BCO5002.001 – Groundwater Impact Assessment Boggabri Coal Mine Modification 10 – v06.02 Appendix E

**Document #1:** AGE, 2025. Groundwater Impact Assessment Boggabri Coal Mine Modification 10. BCO5002.001 Report for Xenith Consulting Pty Ltd. v06.02,27 May 2025. 143 pages + 6 Appendices.

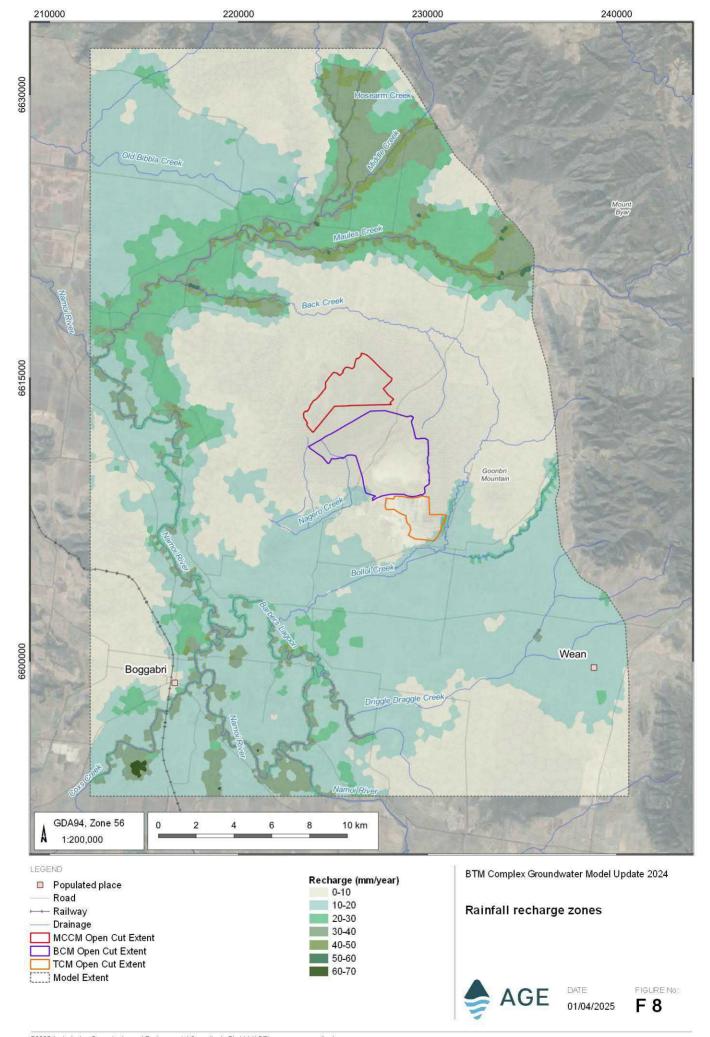
Rainfall recharge rates, initially determined using a soil-moisture bucket model, were subsequently adjusted using pilot point multipliers during the calibration process. The average annual recharge rates, displayed in Figure F8 (Document #2), range from zero

Rainfall recharge rates, initially determined using a soil-moisture bucket model, were subsequently adjusted using pilot point multipliers during the calibration process. The average annual recharge rates, displayed in Figure F8 (Document #2), range from zero to 70 millimetres per year (mm/year) (that is, 0-11% of annual rainfall). The alluvial areas lie mostly in the 10-30 mm/year range (that is, 1.6-4.8% of annual rainfall). These values are plausible and are consistent with other studies in the Upper Namoi Valley. A recharge rate of 2% has been adopted (not calibrated) for spoil; this lies within typical expected rates of 1-10%.

Figure F 17 Transient calibration – modelled vs observed groundwater levels

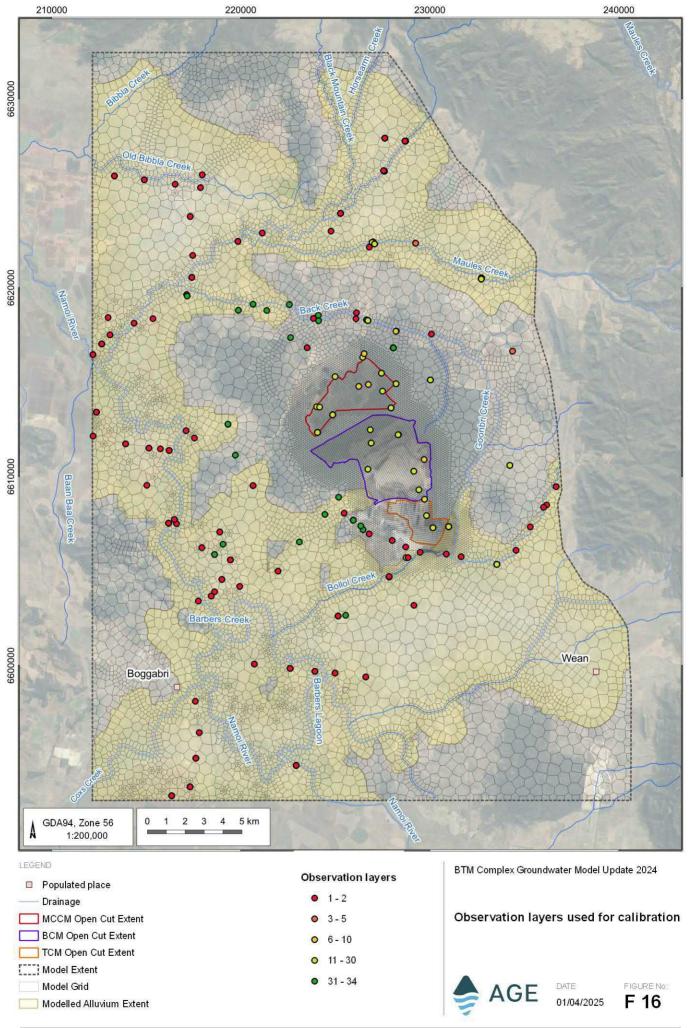
Calibration performance is demonstrated by comparison of measured and simulated hydrographs (Section F13, Document #2), statistical measures and a scatter plot (Figure F17, Document #2) showing performance separately for five different monitoring networks. Visually, there appears to be a slight bias to overestimation of groundwater levels, with three outliers associated with two bores at MCCM and one bore at BCM (IBC2114; now mined through). A reasonable explanation is offered for these anomalies, namely unreliable interpolation at pinch-out contacts.

Calibration performance is demonstrated by comparison of measured and simulated hydrographs (Section F13, Document #2), statistical measures and a scatter plot (Figure F17, Document #2) showing performance separately for five different monitoring networks. Visually, there appears to be a slight bias to overestimation of groundwater levels, with three outliers associated with two bores at MCCM and one bore at the Boggabri Coal Mine. A reasonable explanation is offered for these anomalies, namely unreliable interpolation at pinch-out contacts.

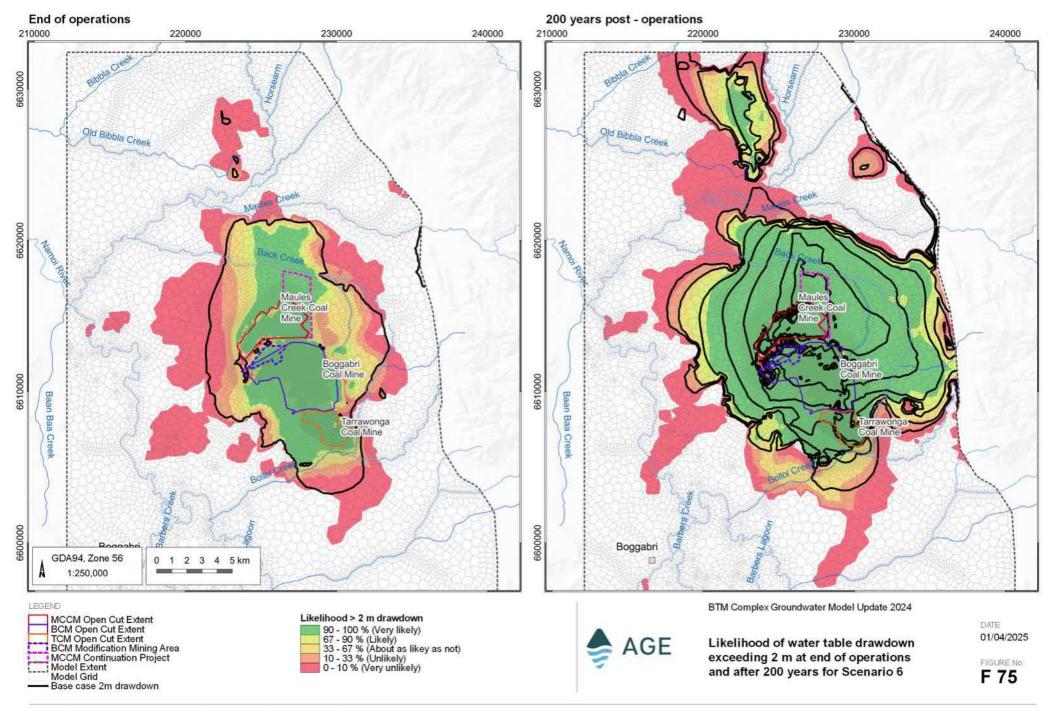
The constrained *monte carlo* approach results in Figure F75 (Document #2) for the likelihood of water table drawdown exceeding 2 m. This map is presented in the format recommended in the latest IESC Explanatory Note (Peeters and Middlemis, 2023), using the standard language and colour scheme in Table F19 (Document #2). The range of likelihoods seems plausible based on experience with uncertainty ranges produced by standard *monte carlo* UA.

The constrained Monte Carlo approach results in Figure F75 (Document #2) for the likelihood of water table drawdown exceeding 2 m. This map is presented in the format recommended in the latest IESC Explanatory Note (Peeters and Middlemis, 2023), using the standard language and colour scheme in Table F19 (Document #2). The range of likelihoods seems plausible based on experience with uncertainty ranges produced by standard Monte Carlo UA.
